Electric Step Improvements

Applies to KwikEE Step Series 22, 23, 24, 25, 26, 28, 30, 31, 32, 33, 34, 35, 36, 37, 38, 39, 40, 42 and 44

KwikEE announces the replacement of specific parts on KwikEE Electric Steps with improved components.

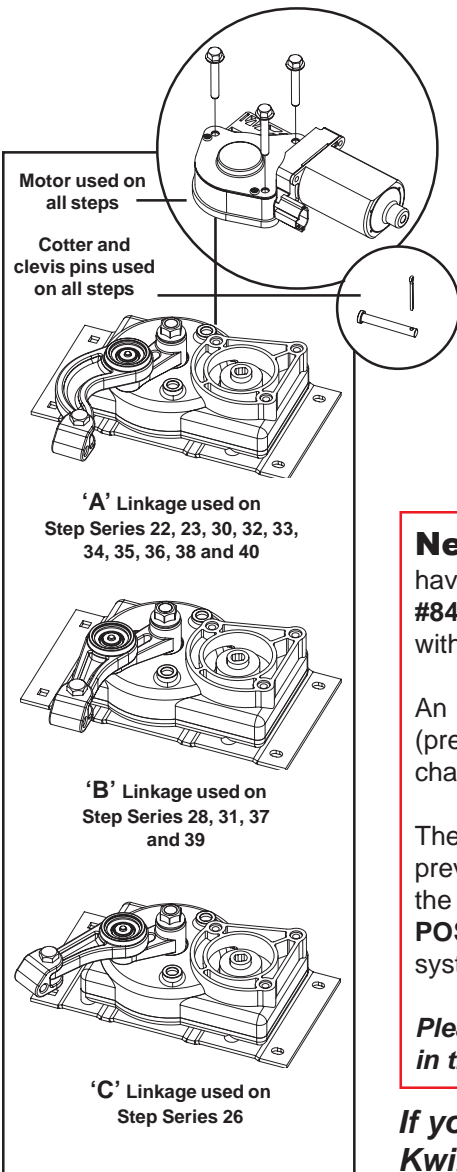
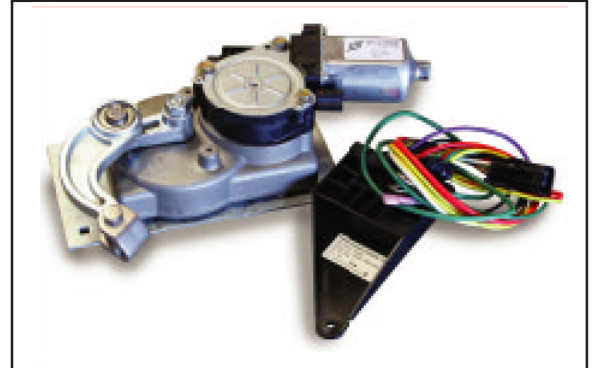
New parts include:

- Linkage and Gear Box
- Motor*
- Control Unit+

Improved linkage and gear box Investment cast zinc plated steel linkage assembly is strong and more resistant to corrosion. Brass spherical outer cage with hardened ball in linkage is stronger, wears longer, and will not oblong. Improved gear box has fully sealed dual ball bearings for greater efficiency and no maintenance. Case halves seal for consistent alignment and gear protection from the elements.

Improved motor 40% more motor torque gives the step a strong lock-out and solid feel.

Improved control unit logic Step is always open when door is open. Step can be locked in the extended position. Step cannot be locked in retracted position. Automatic ignition override makes step follow door.
